February 22, 1990
LD-90-017

Subject: Revision to UNC-2901 Shipping Container
Certificate of Compliance Amendment Request

CERTIFICATE OF COMPLIANCE NO. 6294

UNC-2901 SHIPPING CONTAINER

TITLE
PELLET
TRAY HOLDER

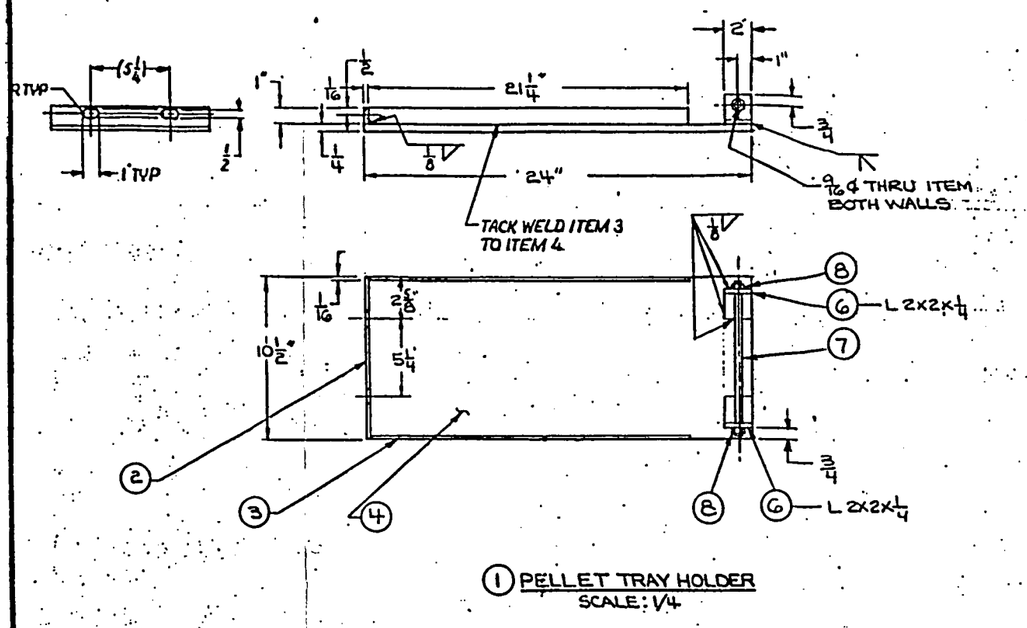
REV	DESCRIPTION	BY & DATE	CHK'D & DATE	ENGR APPR	PROD APPR
01	1-BM (FACE OF DWG DELETED ITEM 5 & ADDED ITEMS 6,7 & 8 & RELATED DIMS PER REQ REQ # 87-650				
02	1-CHG'D 1/2 Ø HOLE TO 1/2W x 1LG SLOTS & WELDS WERE 1/16] 3-ADDED TACK WELD NOTE PER REV REQ 88-799

PELLET SHIPPING PACKAGE
16 TRAYS (PELLETS) IN 2901

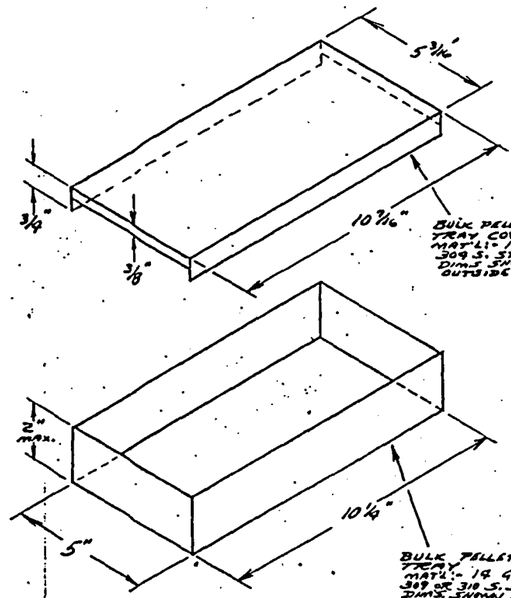
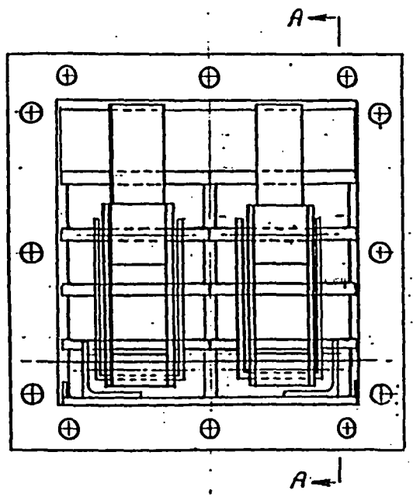
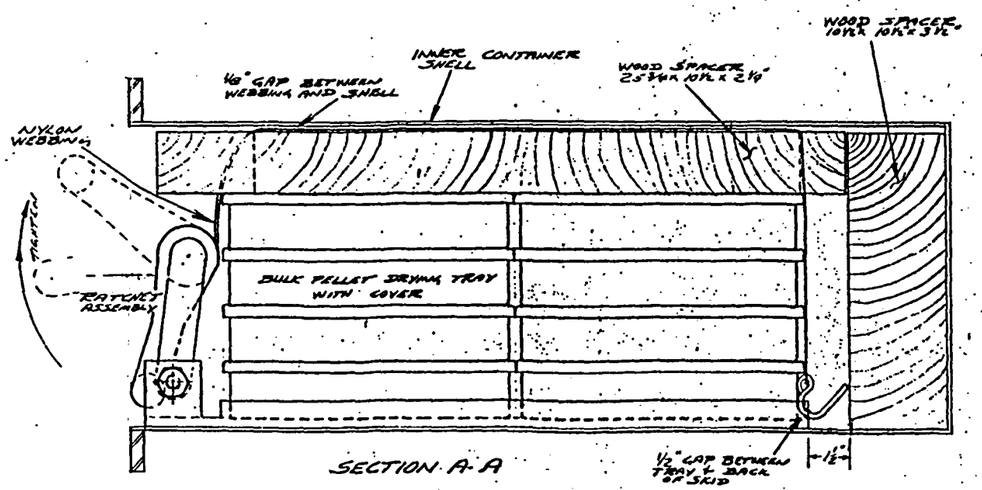
REV.	BY	DATE	APP'D	DATE	DESCRIPTION
1	RLR	5/14/90			TRAY AND LID ADDED

SUGGESTED ASSEMBLY OF 2901 PLYWOOD INSERT

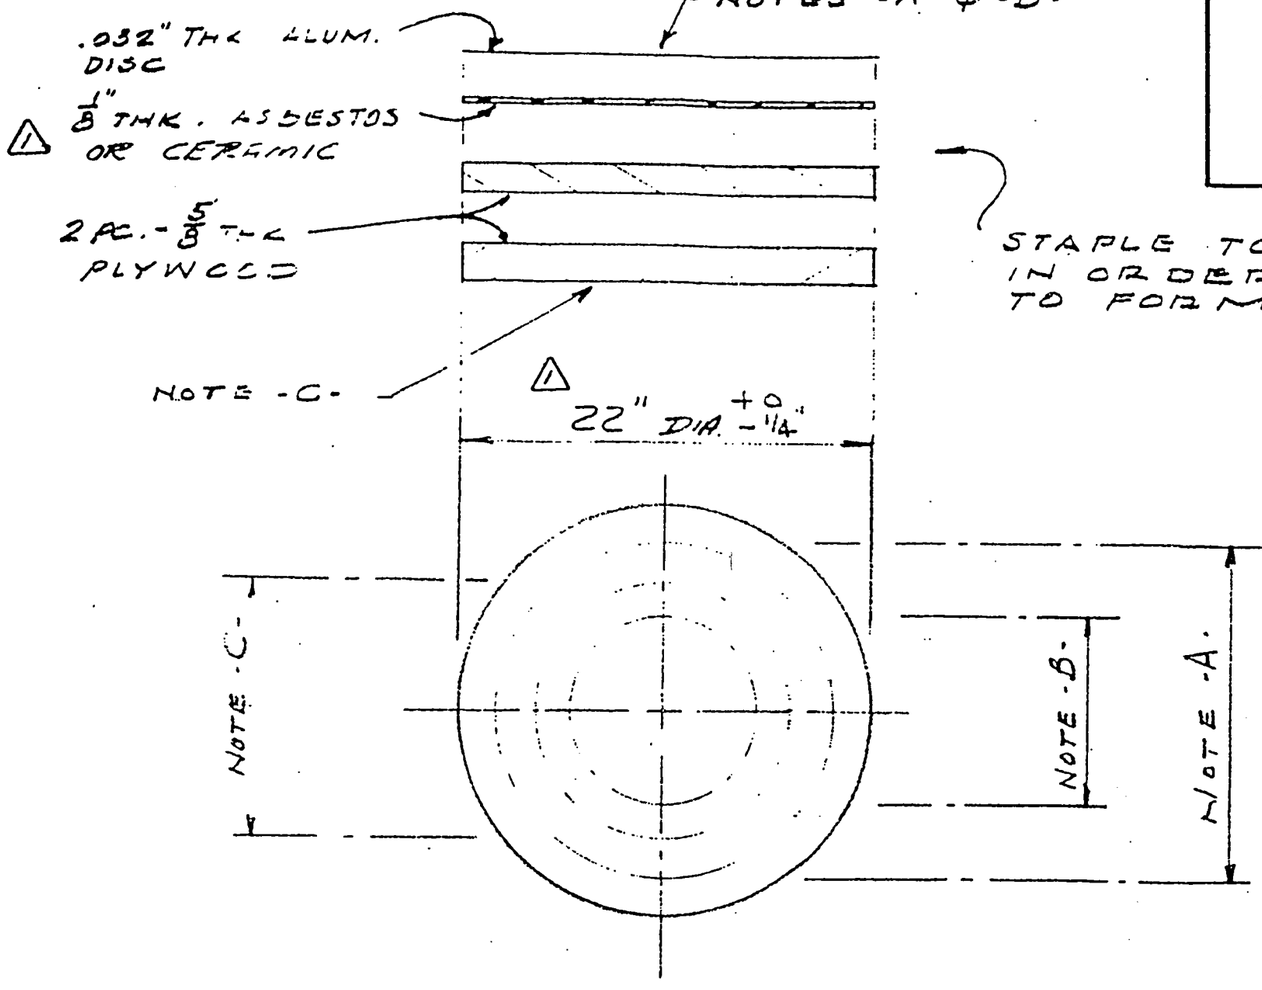
REV.	BY	DATE	APP'D.	DATE	JOB NO.	DESCRIPTION	W. O. NO.
1	RLR	10/31/87				1/8" TK. ASB. OR CERAMIC. WAS ASBESTOS - DIA'S WERE 21 3/4

5-PPP-UO2 POWDER AND HARD SCRAP SHIPPING CONTAINER ASSEMBLY DETAILS

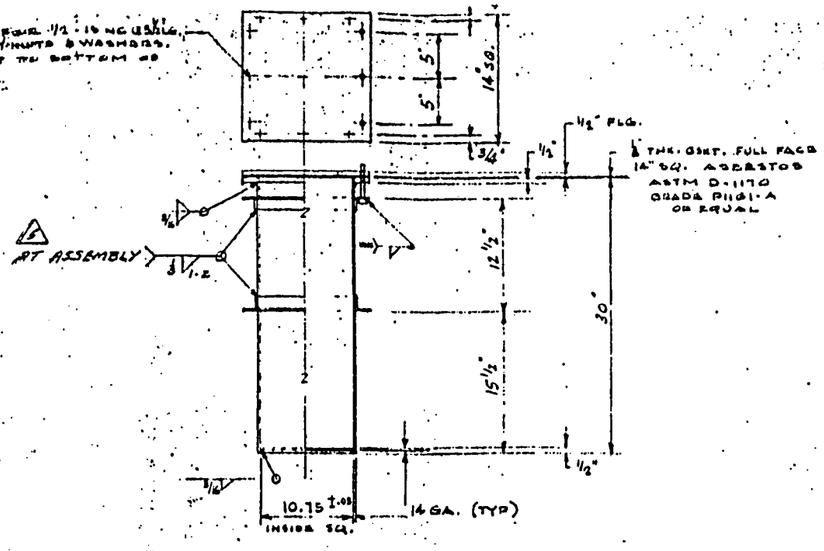
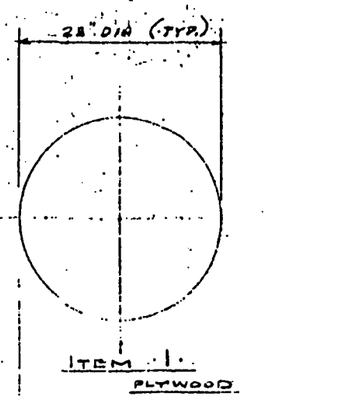
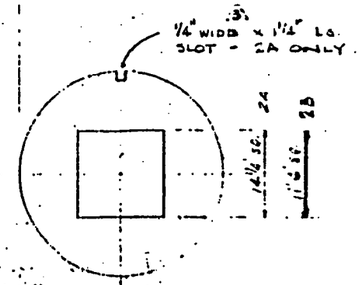
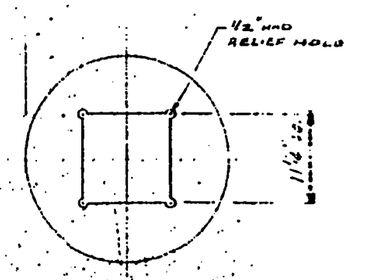
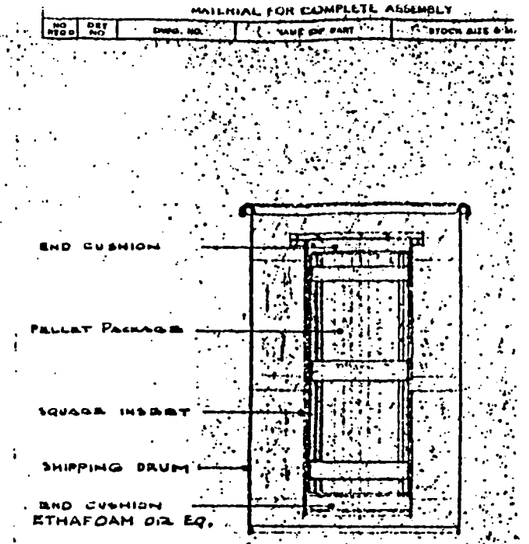
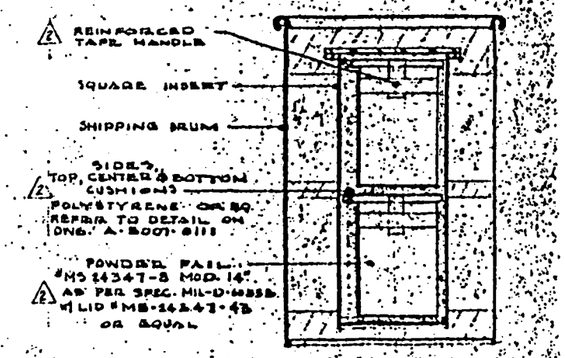
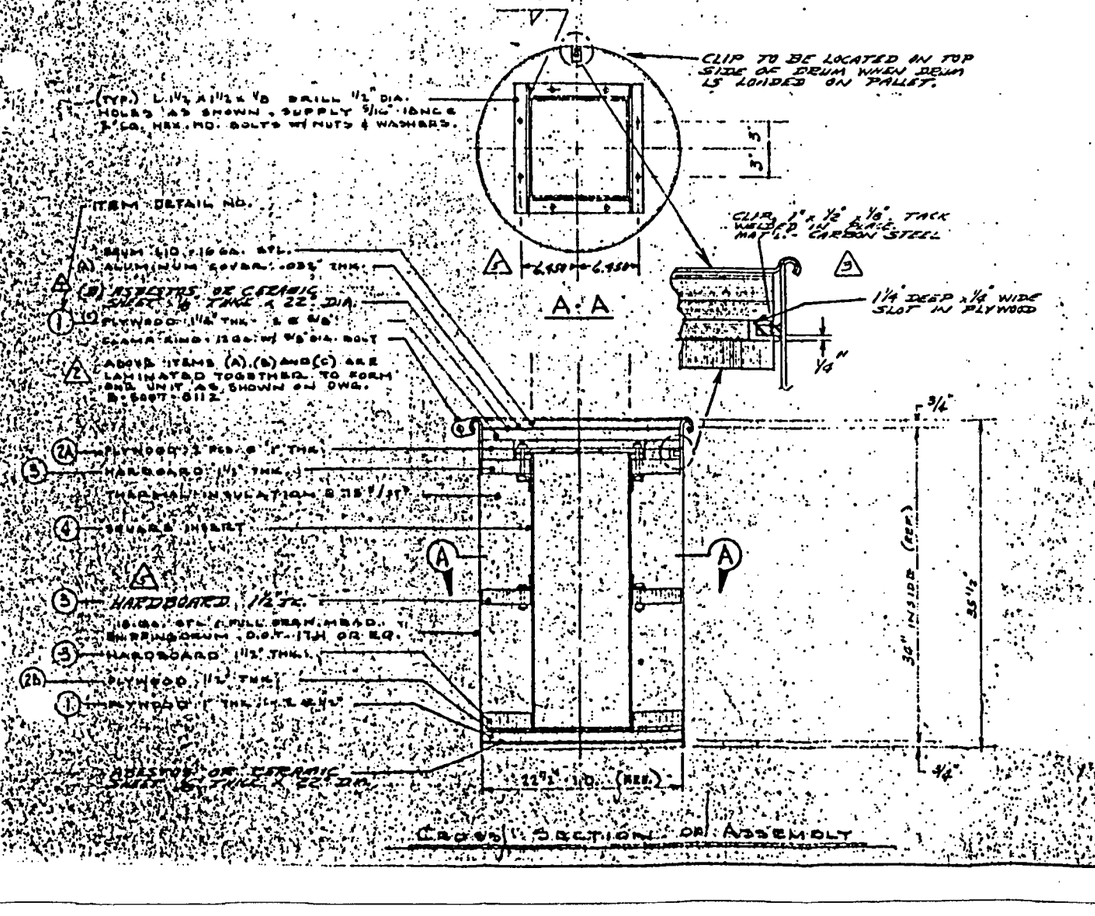
NO	DATE	DESCRIPTION	BY
5	1/30/89	INSERT ITEM 4 - 14" SQ. ASBESTOS GASKET 1/2" OF CONSTRUCTION (TYP.)	RK
4	11/1/87	ADD THK. ASBESTOS OR CERAMIC SHEET (B) ITEM	RK
3	9/9/87	CLIP, 1" x 1/2" x 1/8" ADDED.	RK
2	11-25-86	CHG. NO. OF 5/8" ø ASBEST. HOLES FROM 4 TO 8 EQUAL SPACED. CHG. DIM. 2 TO 2A.	VAL
1	5-17-86	REDRAWN	VAL
